### STAFF RECOMMENDATION

#### **Docket LU-24-0014: O'Conor Access Road**

**Request:** Limited Impact Special Review for 1,254 cubic yards of non-foundational earthwork for construction of a new driveway to access the existing residence on an approximately 3-acre parcel at 254 Left Fork Rd.  
**Location:** 254 Left Fork Rd, parcel number 146130000021, approximately 0.7 miles north of the intersection of Sugarloaf Rd and Mountain Pines Rd, Section 30, Township 1N, Range 71W.  
**Zoning:** Forestry (F)  
**Applicant:** Andrea O'Conor (Owner)  
**Agents:** Gino Cornella and David Lucas

SHEET NO  
**C1**

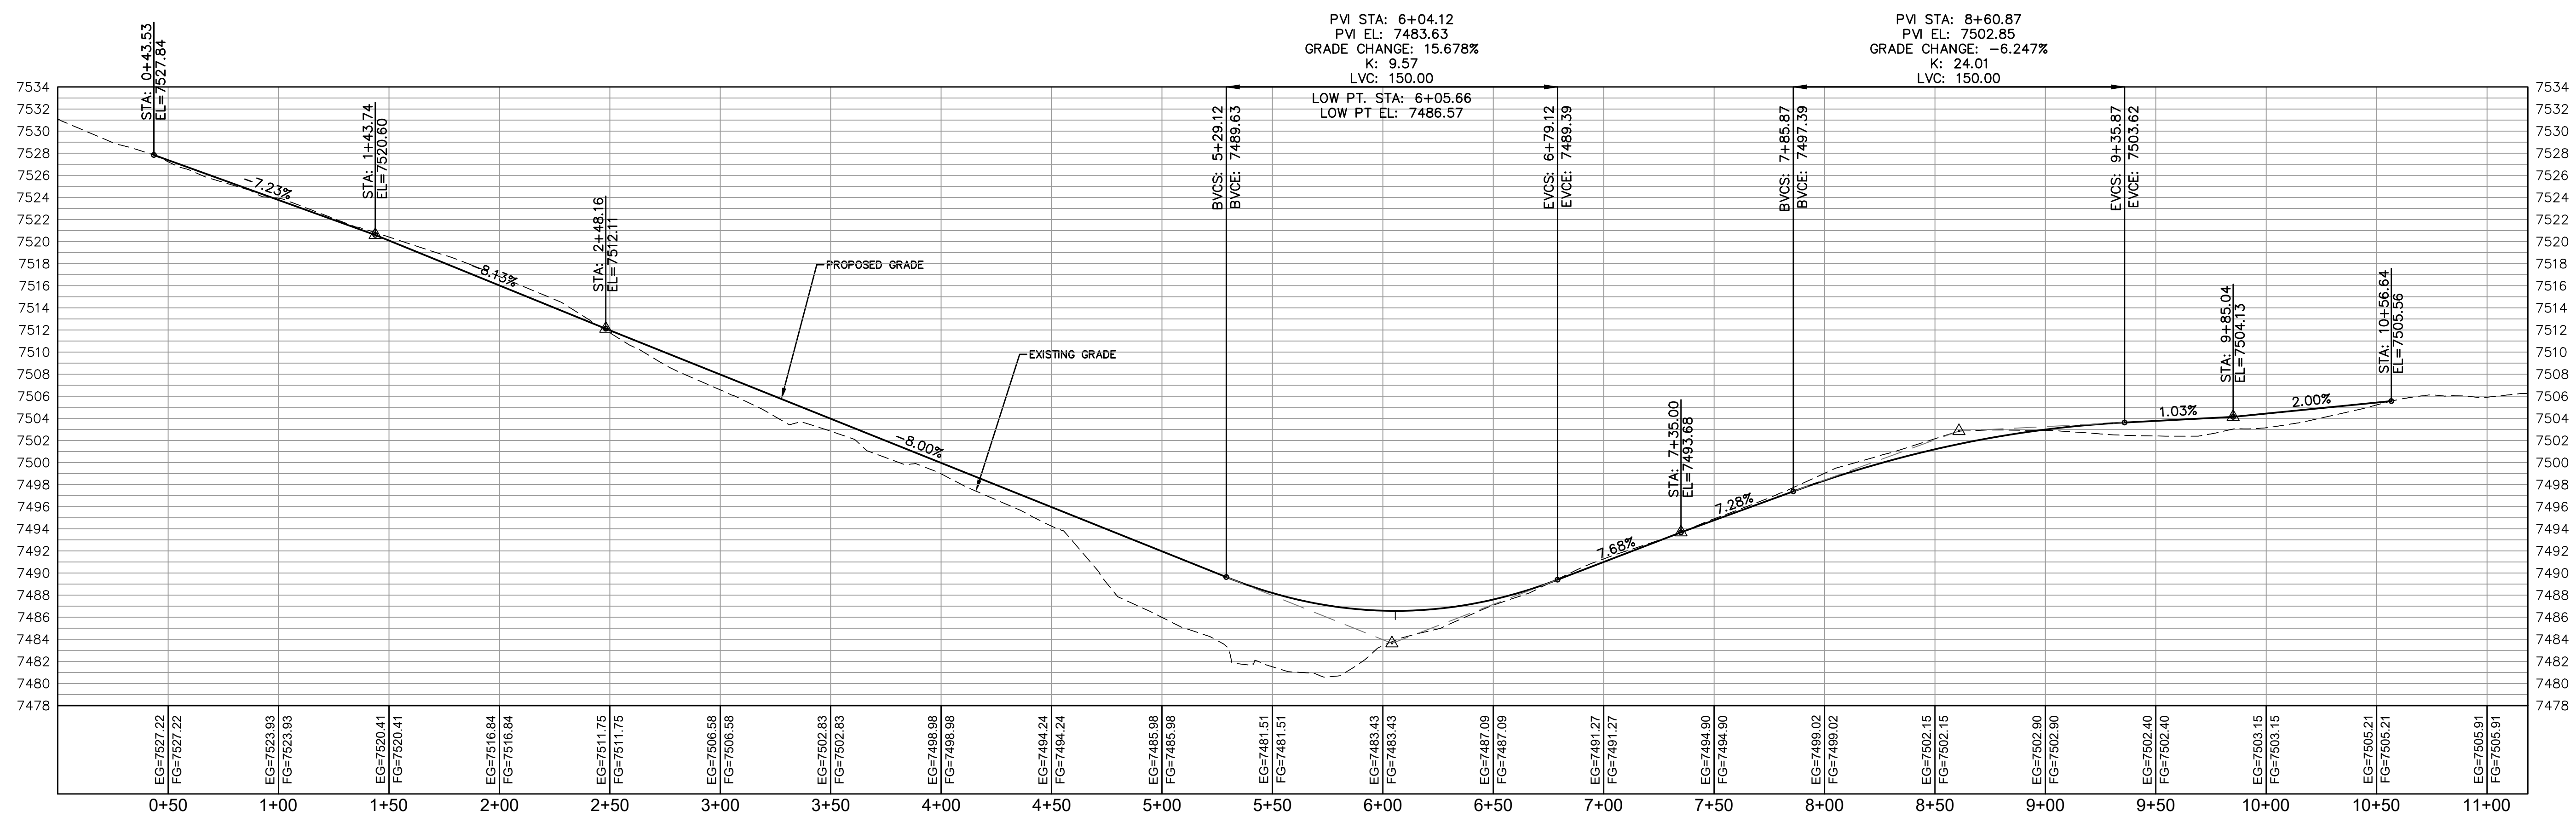
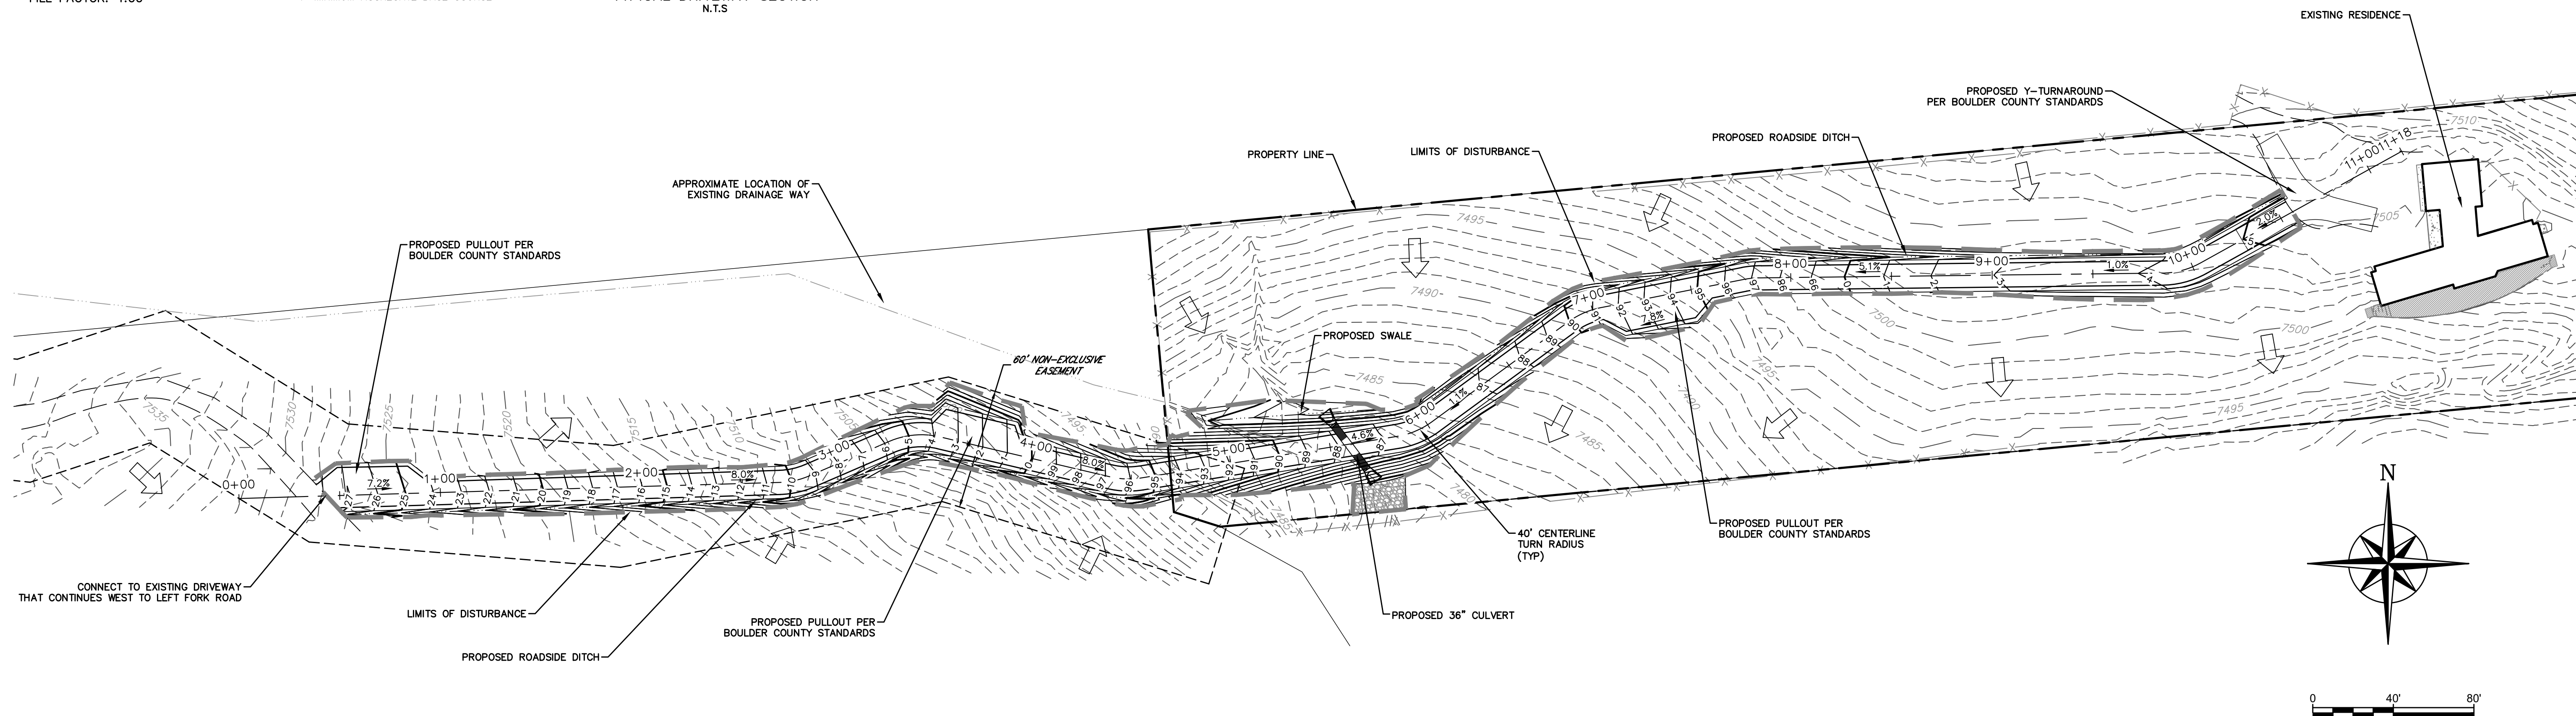
- a. At some points on the plan, the improvements are proposed very close to the easement and property line. The easement boundaries and property line should be staked between Stations 4+00 and 6+00 of the road alignment to ensure no grading or placement of riprap occurs beyond the easement and subject property.
- b. The pullout beginning at approximately Station 3+50 incorporates tapers that do not meet the Standards.
- c. The radius of the “Y” turnaround appears to exceed the required 30-foot radius.

- a. Provide calculations and cross sections for swales and ditches. Specify whether or not check dams, TRM lining, or other measures are needed based on velocities.
- b. Please show culvert on driveway profile.

***At building permit***, submit plans that comply with the Boulder County Multimodal Transportation Standards.

SHEET NO  
C3

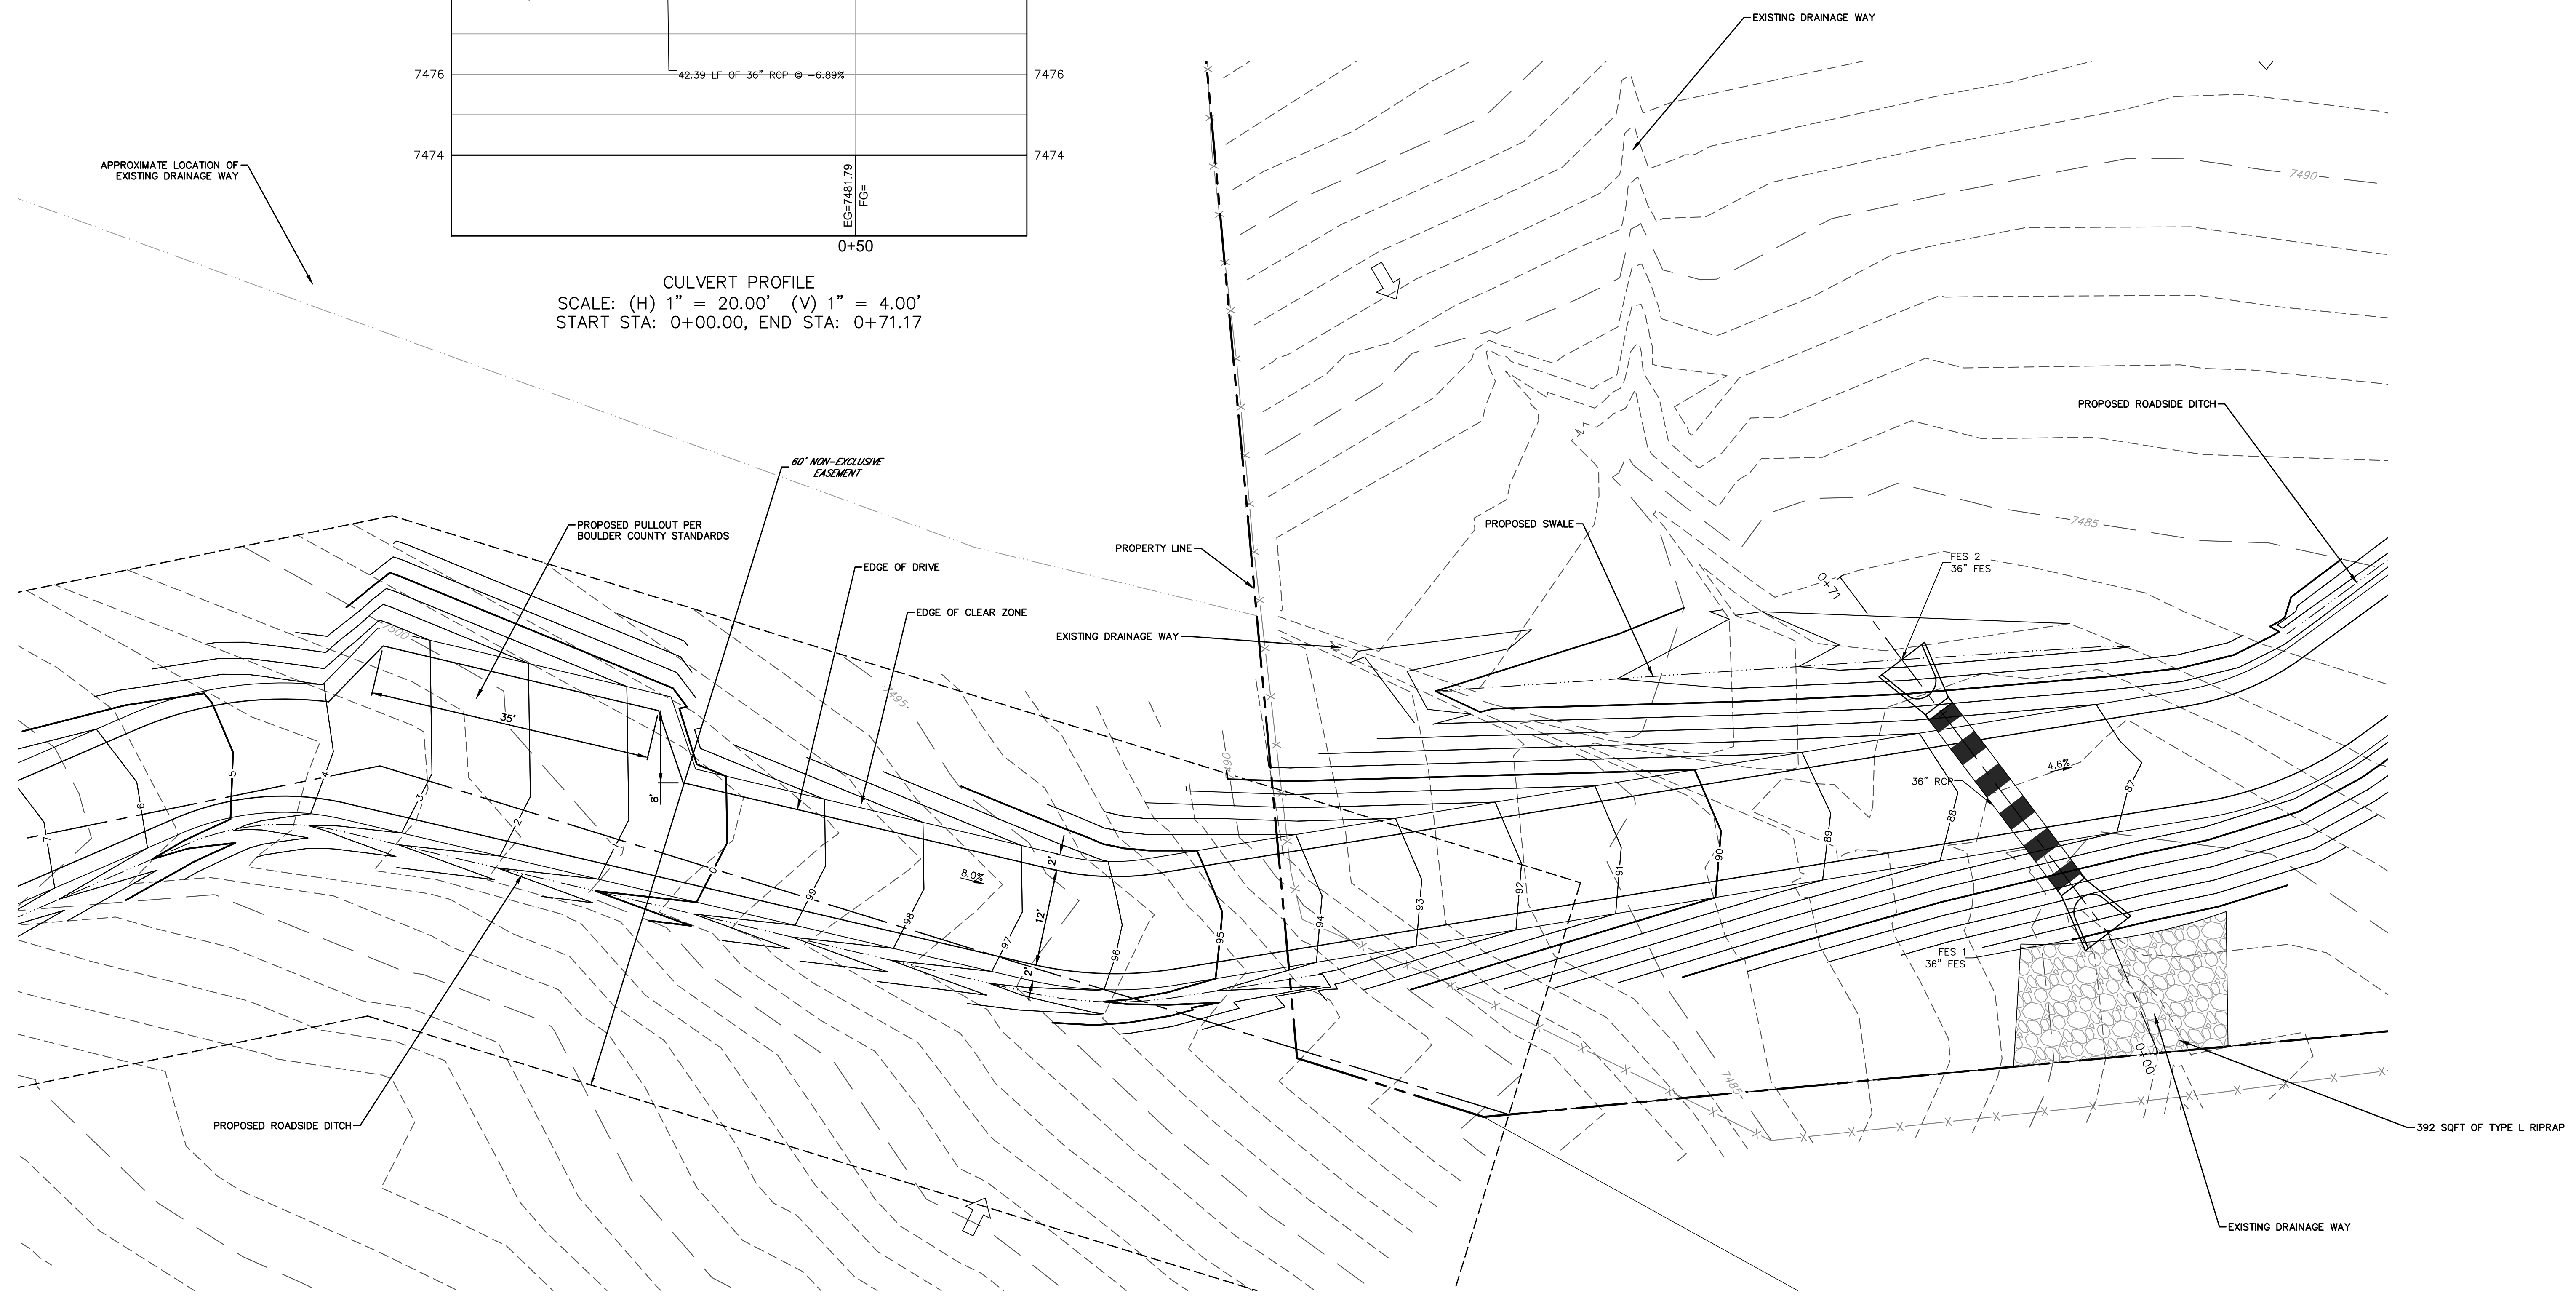
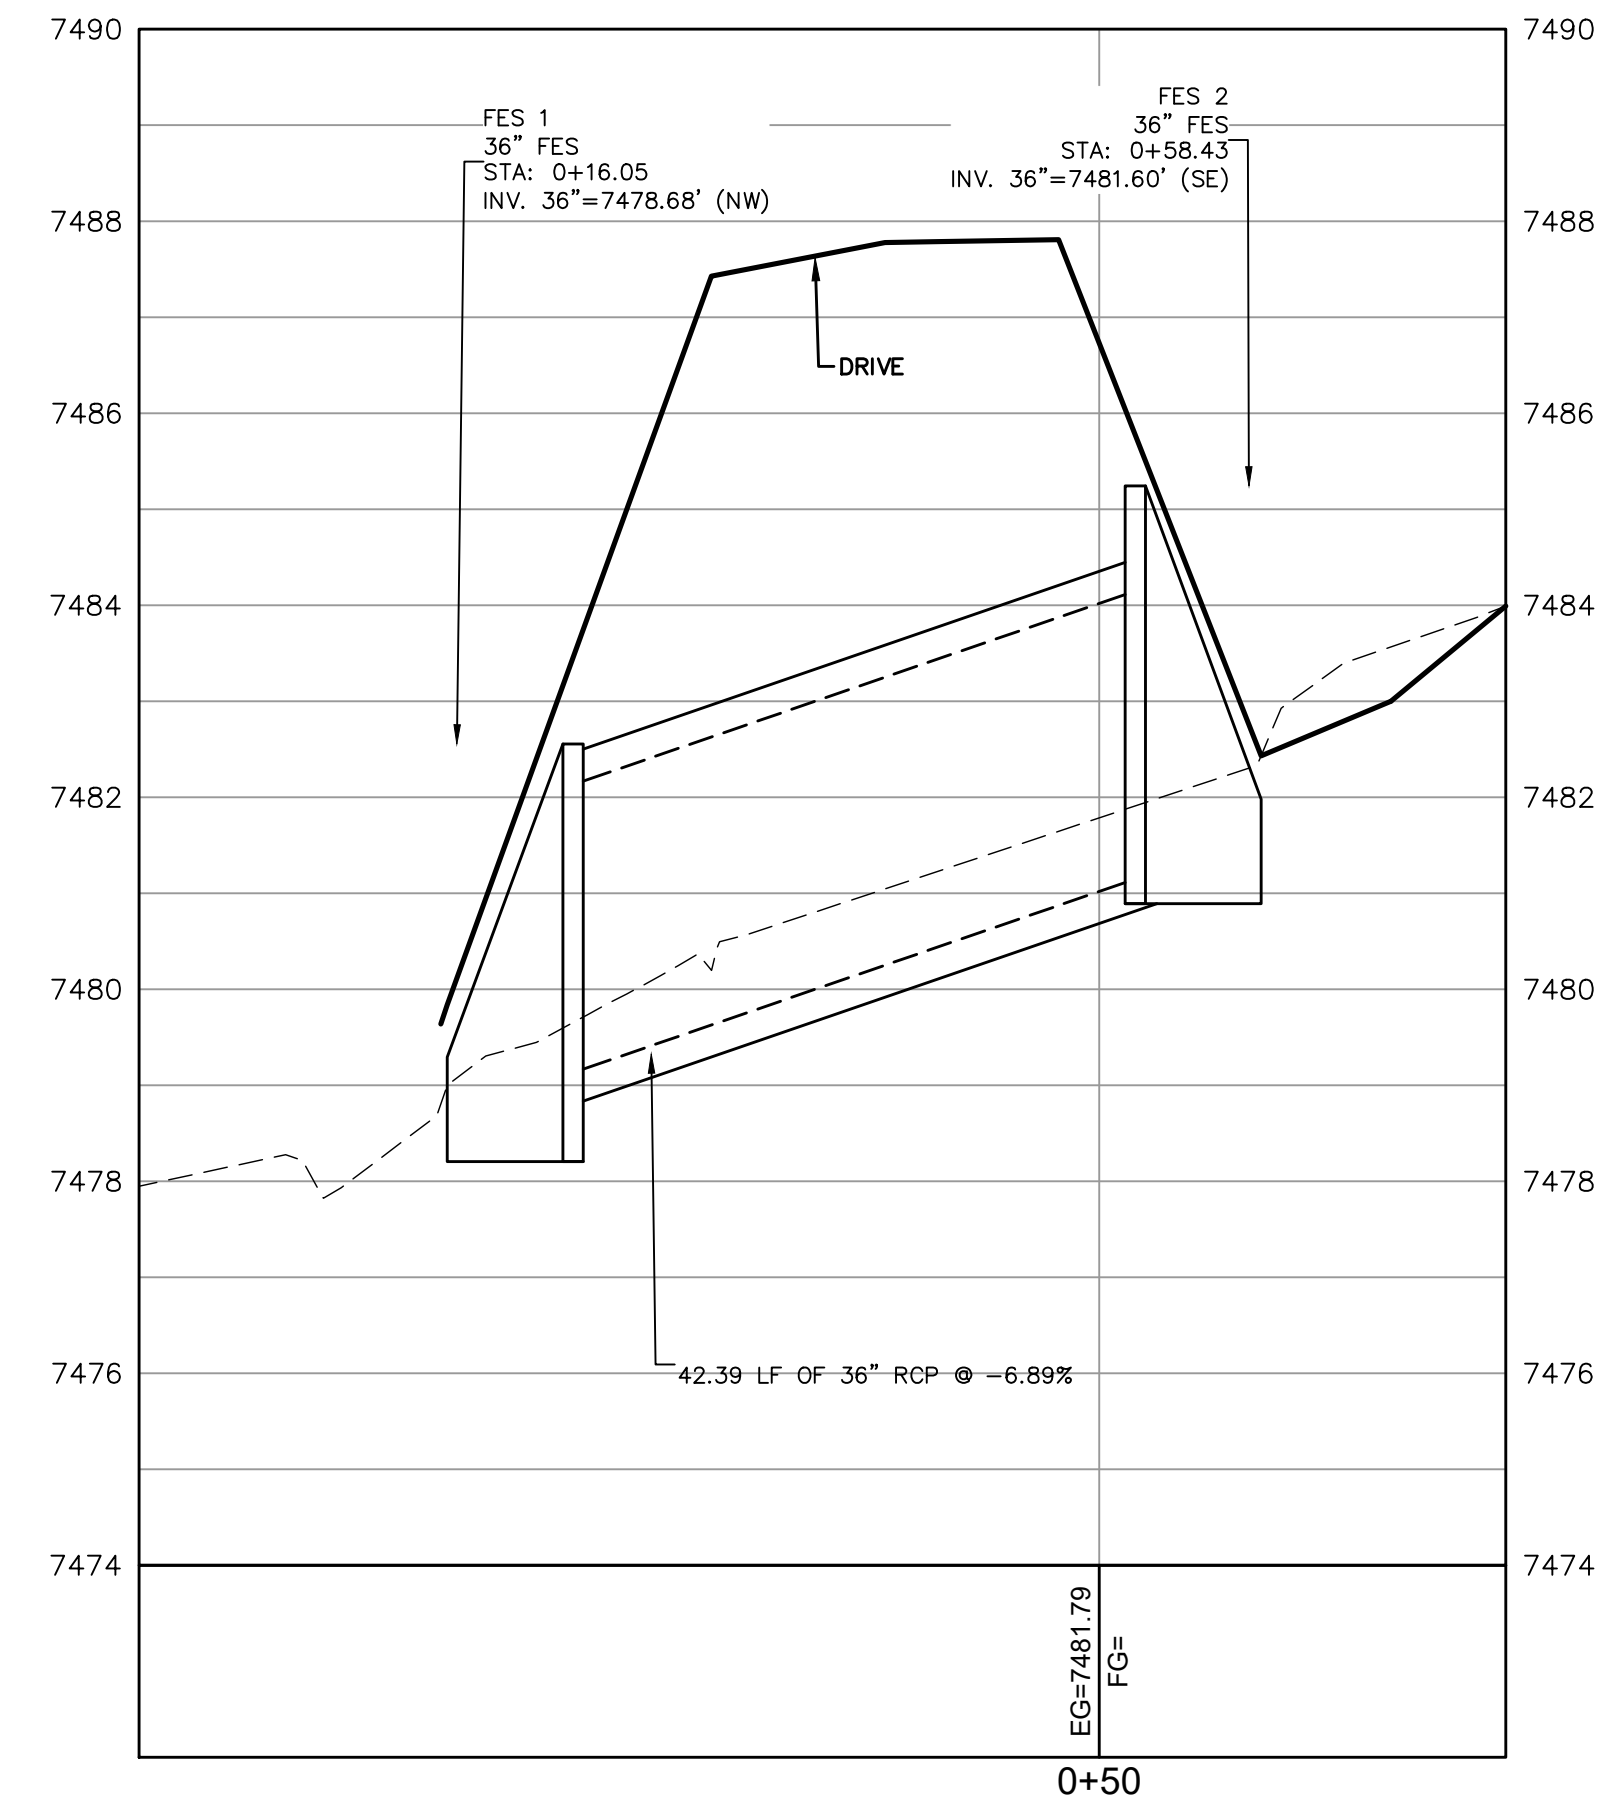
- a. The value used for Hw/D Culvert Report is higher than allowable. Per Mile High Flood District's (MHFD) Culverts and Bridges Chapter, Hw/D should be 1.5 or less in 100-year event. Please revise to stay within this headwater limitation.
- b. Provide design and calculations to show how road and downstream embankment will be protected from erosion when it overtops. The road surface must be armored to protect against erosion during overflow. The current design indicates the culvert has zero freeboard; in this circumstance, the culvert could be partially obstructed leading to overtopping.
- c. Provide calculations for riprap sizing and length of pad downstream of culvert using MHFD Culvert or comparable calculations.
